# Comments on 9th Feb Draft

Dick Ferris 31/3/00

Figure 3 VSI TVG has acquired a control circuit:

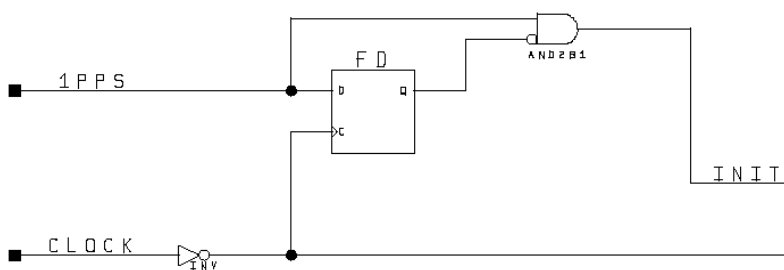
Since 1PPS is by definition already synchronous with CLOCK, the introduction of an inverter into the clock line as shown creates a timing race. While the intention is clear this is not appropriate for an engineering standard!

Given that in a real design both formatting the 1PPS/INIT pulse, and generating correctly phased bit-streams and CLOCK, will most likely happen elsewhere it is preferable to just stick to defining the logical process of generating the PRNs. e.g. Return to showing the sequence generator controlled by RESET (1Hz) and CK plus a supporting waveform diagram in the manner of the original CRES Tech drawing. The design engineer can then incorporate this function and resolve the relationships with VSI specific waveforms in an appropriate manner.
